Queries / Questions and Comments / Answers:

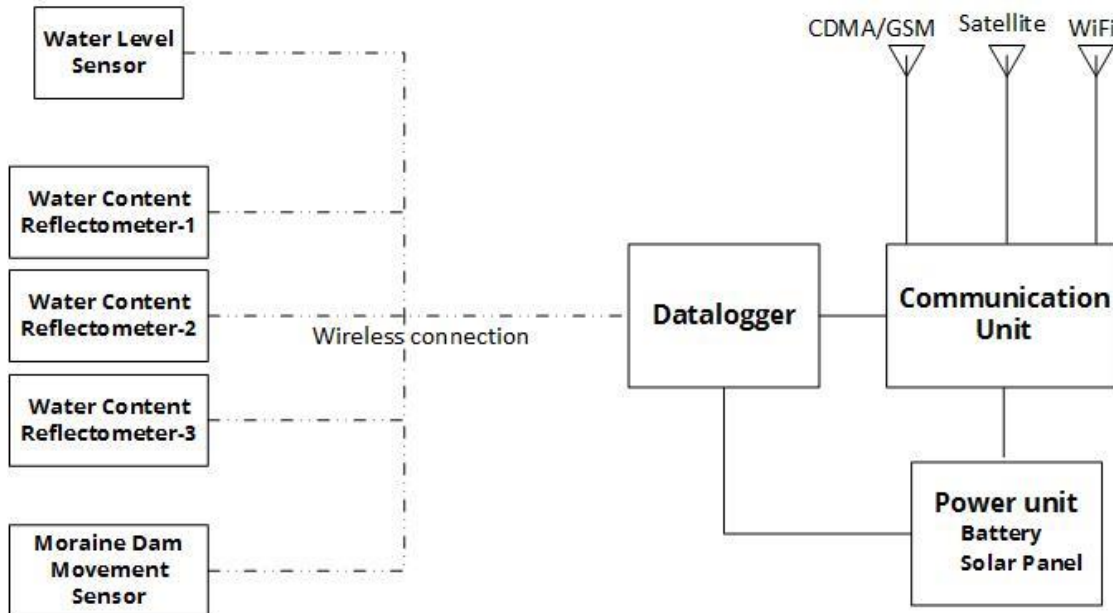
1. Explain a little more about overall block diagram and its performance system.

Block diagram (the sensors should be as indicated in the document).

The overall performance of the system should be:

- The early warning system on Imja Lake is to be installed at remote and accessible through trekking at 5010 masl. So, the reliability of the system has to be very high. The system should also withstand harsh environmental condition and the solar power backup system should last at least a month without solar charging.
- The data transmission should automatically select economical and reliable system according to signal strength and Encrypted data transmission through HTTP and FTP. The CDMA / GSM/ IRIDIUM/ WIFI networks should function simultaneously in a redundant way.
- The audio GLOF Sirens should be Common Alerting Protocol (CAP) compliant.

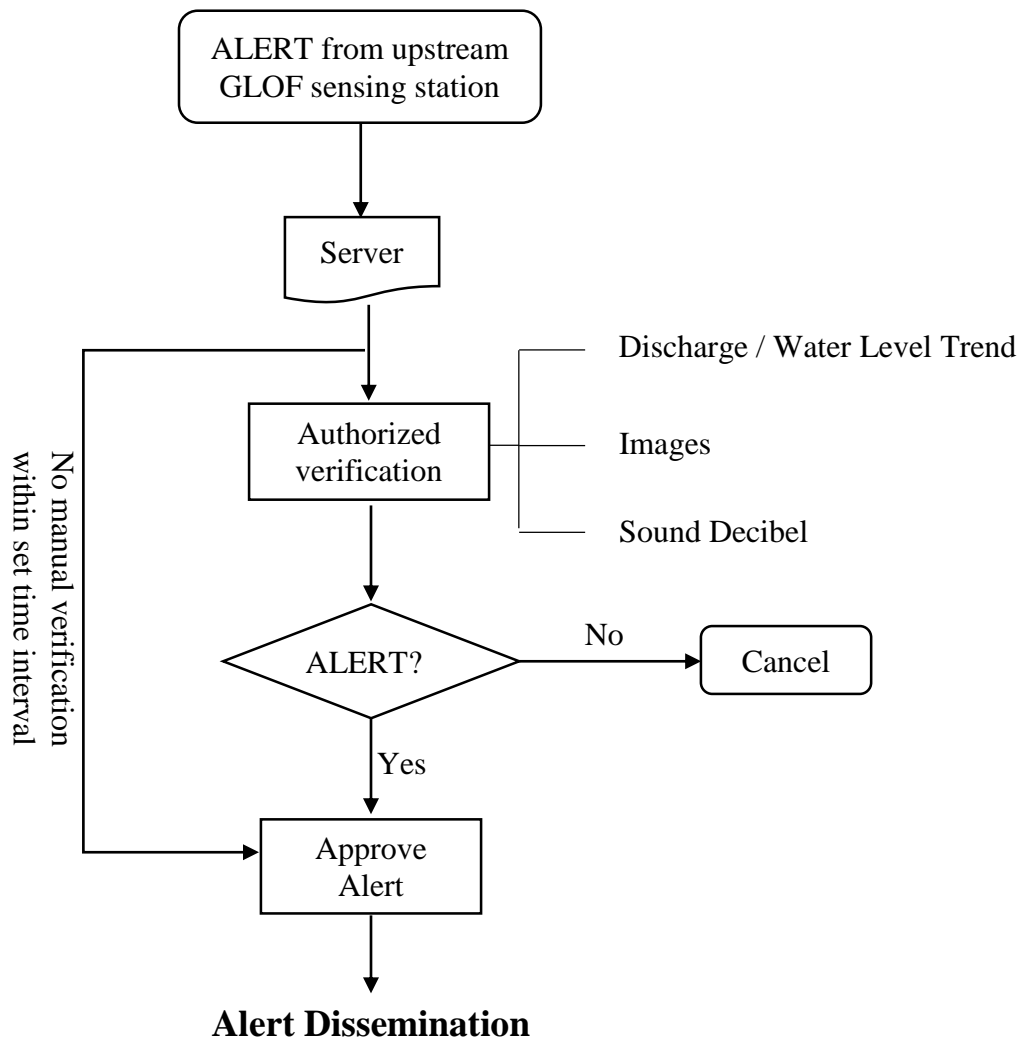
- o Is there an expectation to integrate the existing community warning system with the new one?

- o If so please provide information on the existing system. Make/ model of sirens, number of sites, siren output, linking format, etc.

The automatic siren system will activate 15 community based early warning system (CBEWS) through slave and siren nodes, mobile phones, FM warning broadcast etc.

The hand operated sirens, mega phones, mobile phones and manual water level gauge are provided to 12 Taskforces that operate the CBEWS.
